**LEGAL ADVERTISEMENT
HISTORIC PRESERVATION BOARD
CITY OF PORTLAND
Public comments are taken at all meetings.**

**PUBLIC HEARING
71 INDIA STREET**

TO: Chair Benson and Members of the Historic Preservation Board
FROM: Deborah Andrews, Historic Preservation Program Manager
DATE: May 11, 2017
RE: May 17, 2017 **PUBLIC HEARING**

Application for: Certificate of Appropriateness for Building Addition
Address: 71 India Street, addition to existing Amato's store
Applicant: Dominic Reali Realty LLC.
Architect: Evan Carroll, Bild Architecture

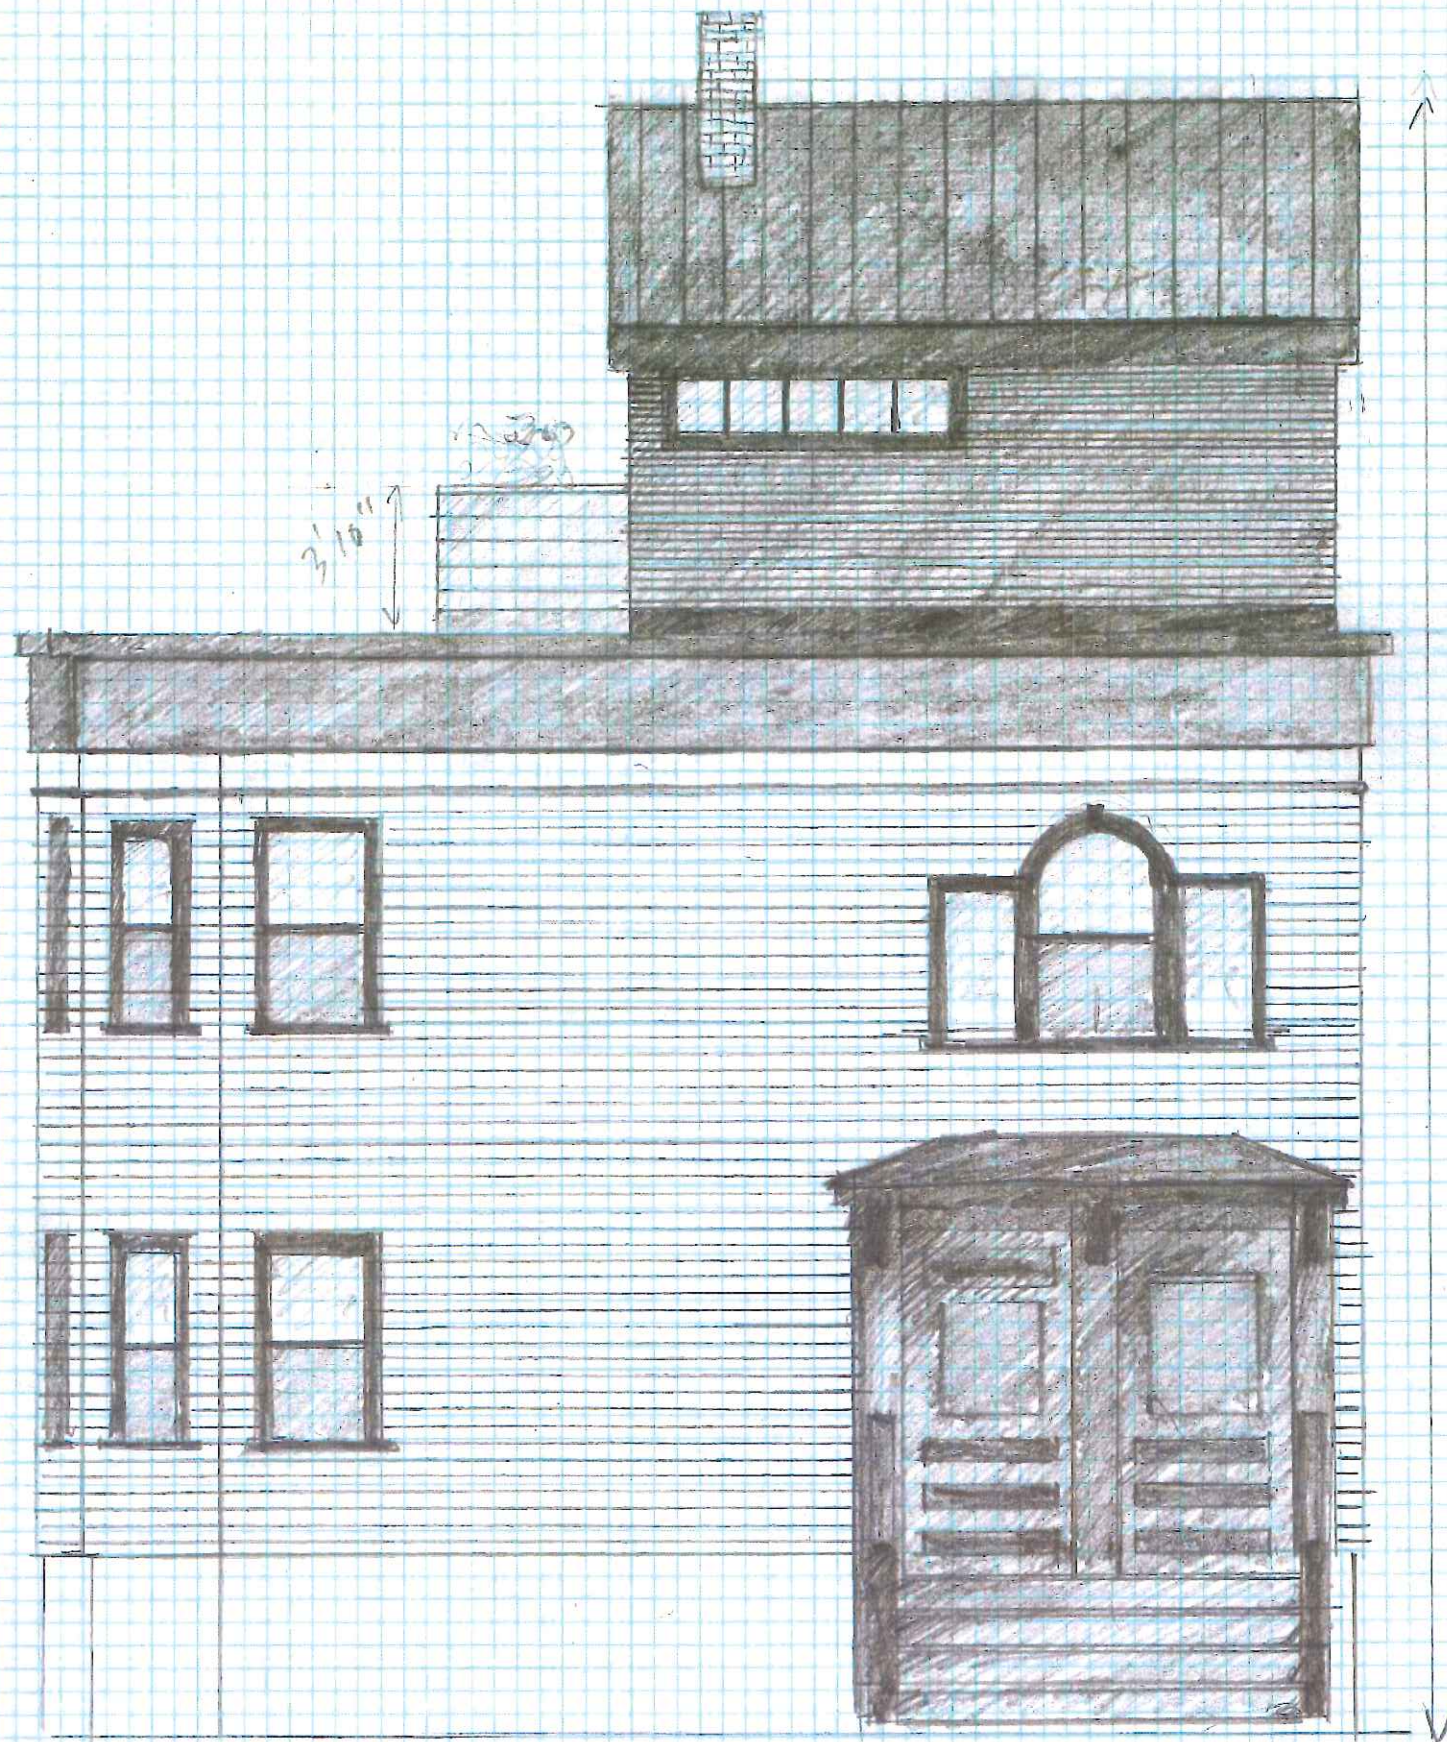
- As before, the color palette is recessive and compatible with the dark trim of the main structure. The siding color presented with the final plans is a medium grey, while the roof, trim, and windows are proposed to be black. Would it be preferable to make the materials as monochromatic as possible? Or is the grey and black scheme that recalls the main structure’s palette a compatible presentation?
- As in the preliminary design, the decking is proposed to be used to side the low walls surrounding the deck. Would a more consistent, uniform appearance be preferable, with the same siding on both the addition and the deck, or is slight differentiation of the

- The current proposed roof height is 10'-5 1/2" at the upper end, while the lower, Pine Street end is still proposed at 7'-2." Would it be desirable to further lower the pitch, reducing the mass of the addition? Would a flatter roof that echoes the existing main roof present a less obvious addition? Mr. Beaudry has stated that the reduction proposed in the final plans is the largest reduction that he would be comfortable with, given the design program and engineering. Raising the wall height at the lower end of the roof would result in a flatter roof profile, but slightly more mass overall, because the lower end would be taller than the current proposed height.

- The front, higher edge of the roof has been lowered to a height of 10’-5 1/2” from the roof surface, while the lower edge is unchanged in the new plans

- The existing chimney has been restored to the plans; apparently removal was more complicated than retaining it and incorporating it into the design
- A dark colored, simple and contemporary cut-off light fixture is proposed for next to the doors at the wall facing the deck (see attachment 7)

PHOTOS OF
AS-BUILT
CONDITIONS

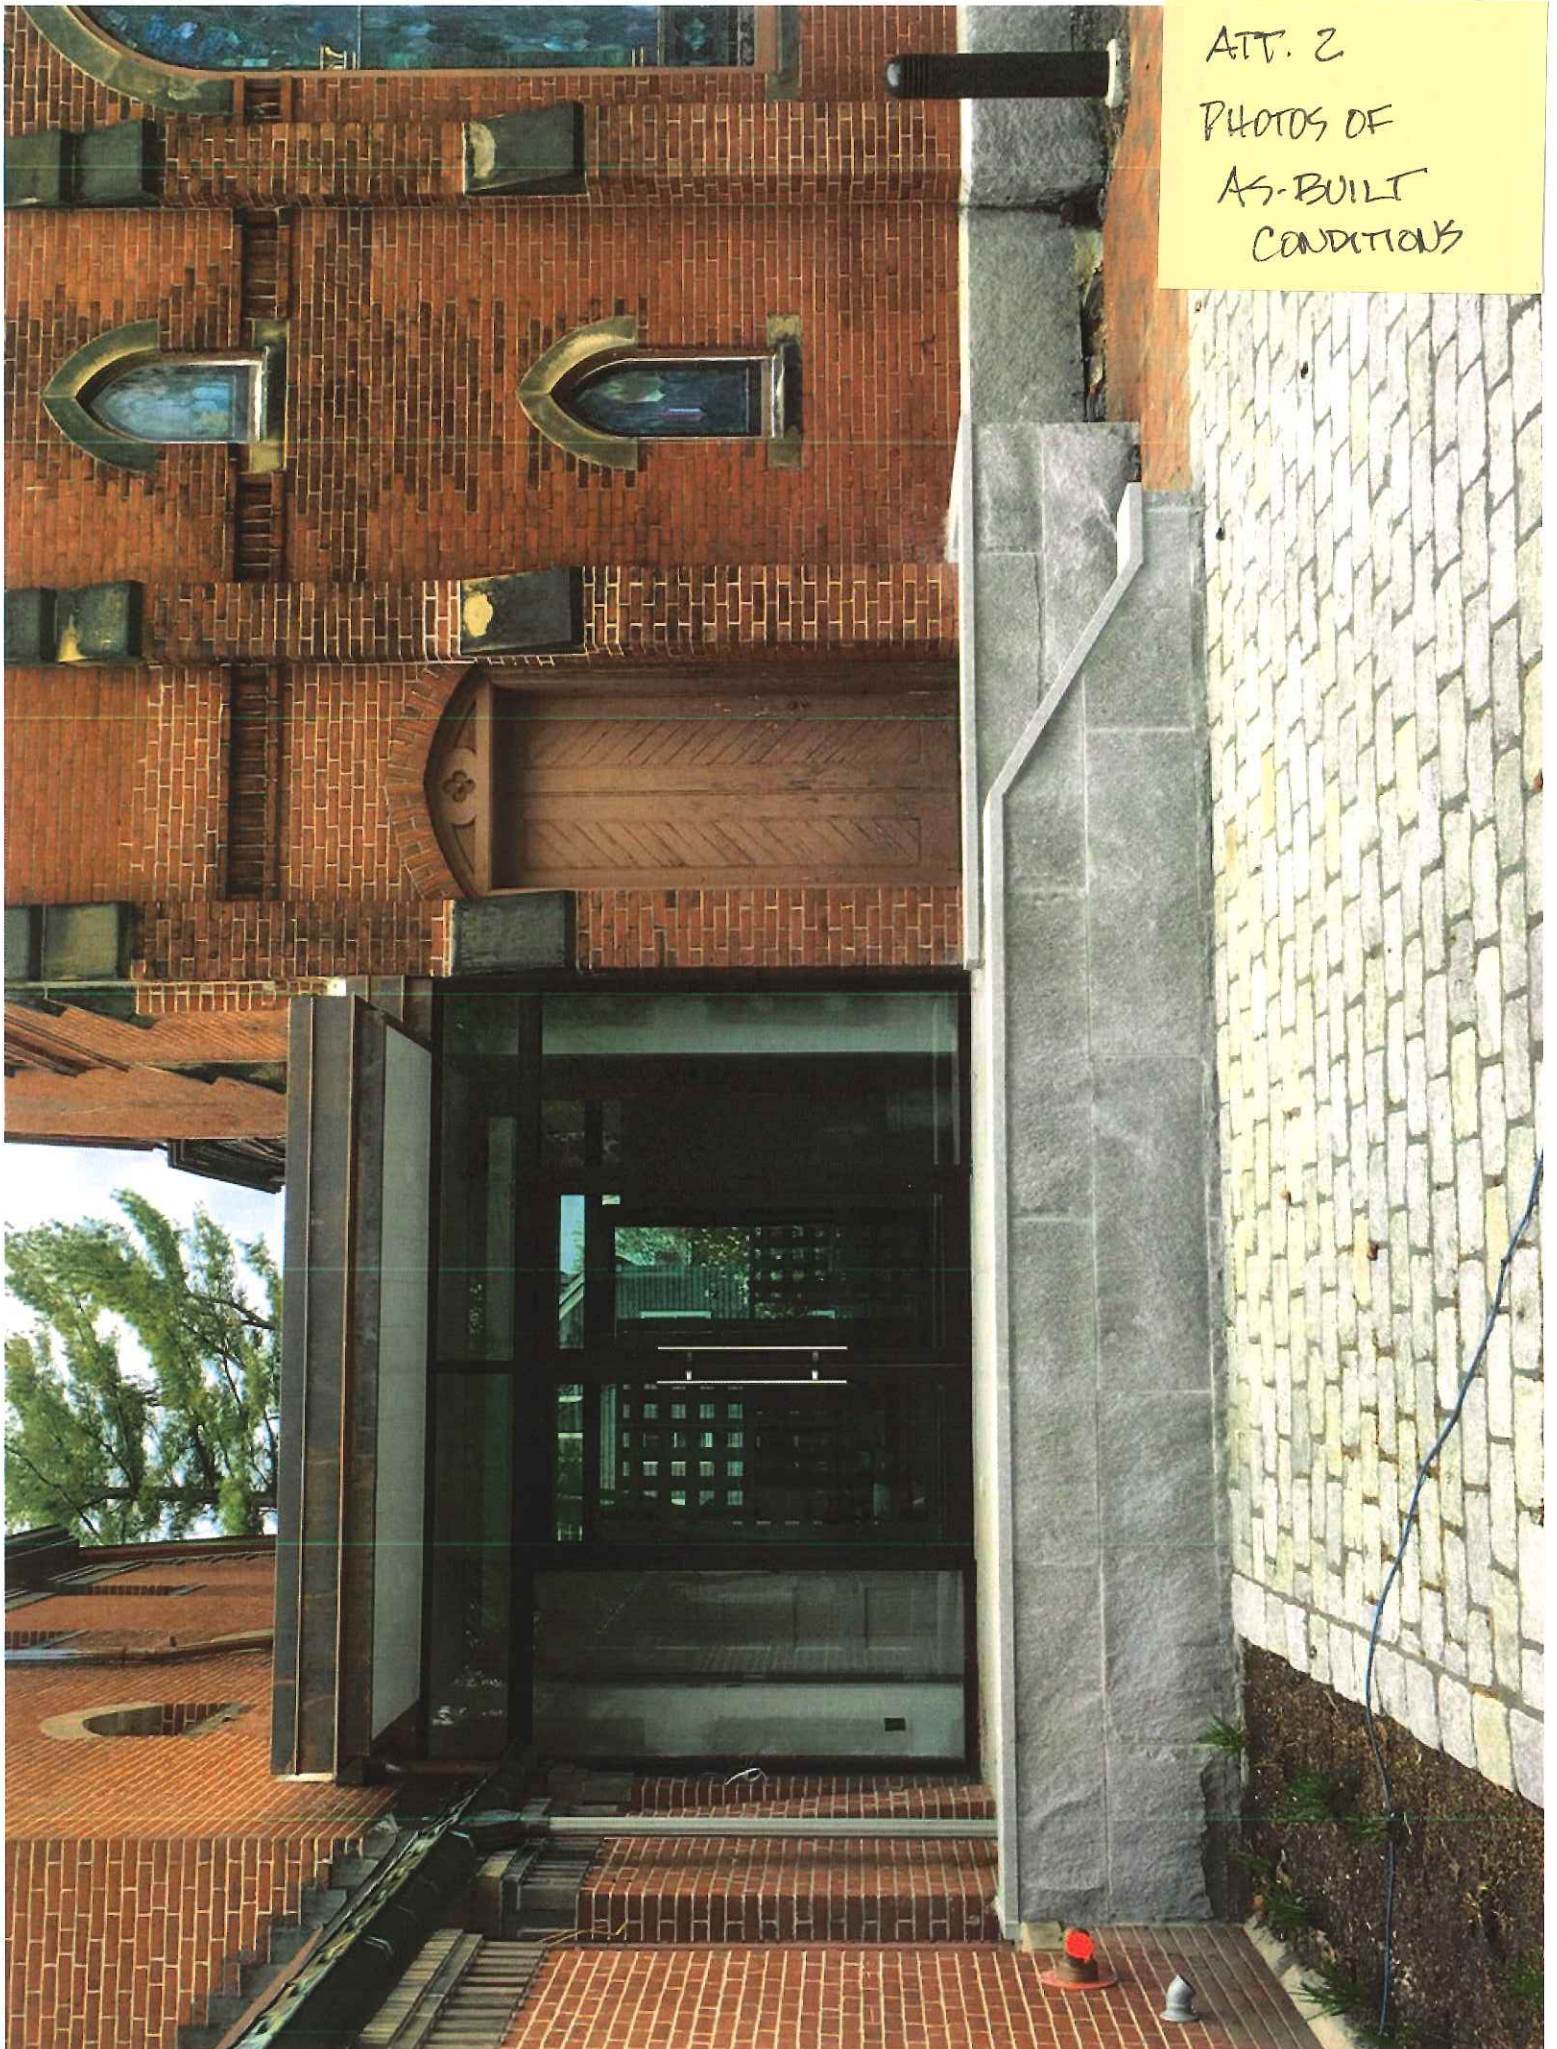
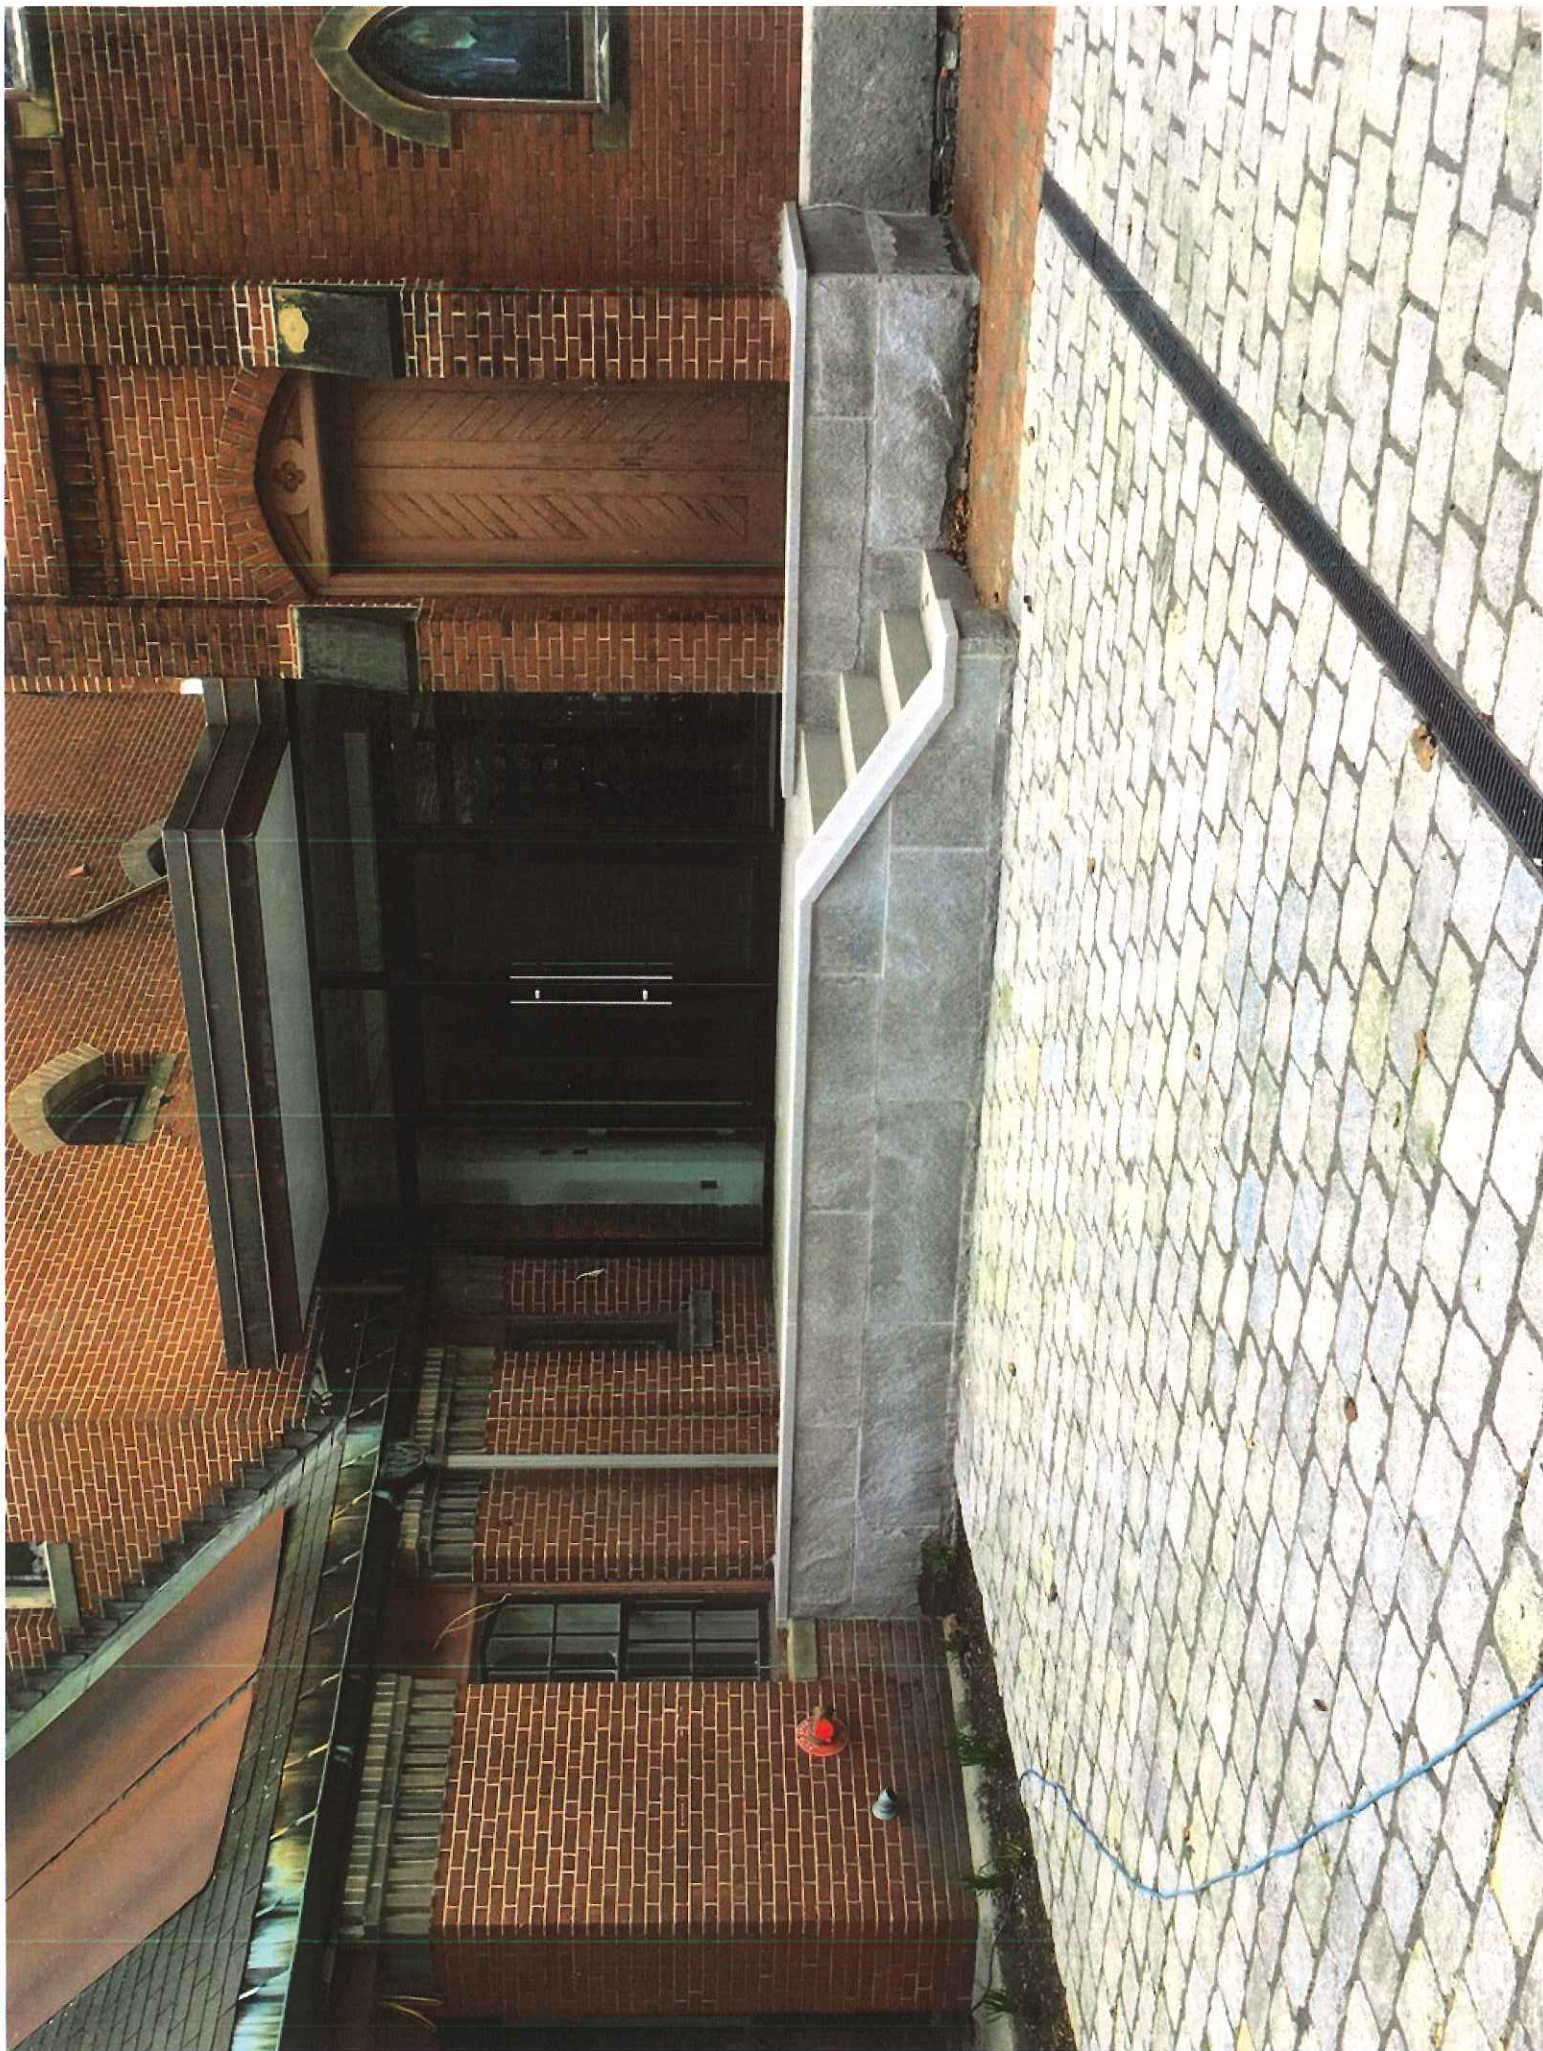
The revised railing was brought to the staff's attention by the contractor at the recommendation of the architect. When Mr. Winch was shown the railing by the general contractor in a site visit, he noted that it did not comply with the approved design and that he had not been provided a shop drawing for final sign-off prior to its fabrication. As built, the railing is 40 inches tall and all components of it feature square edges. The top rail, which was to be graspable in the original design, is squared off and is too high and too wide to meet code in terms of being graspable. To meet code requirements, the fabricator added a lower, graspable handrail inside the railing system at 34" above grade. The entire assembly is bronze anodized aluminum.

In his letter, Mr. Winch describes the circumstances that led to the deviation from the approved plans. The concerns described in the letter do not explain the change in the design itself (which now includes a transom) or the different hardware finish. The decision to change the entry system was made by the project team without advance notice or approval from city staff.
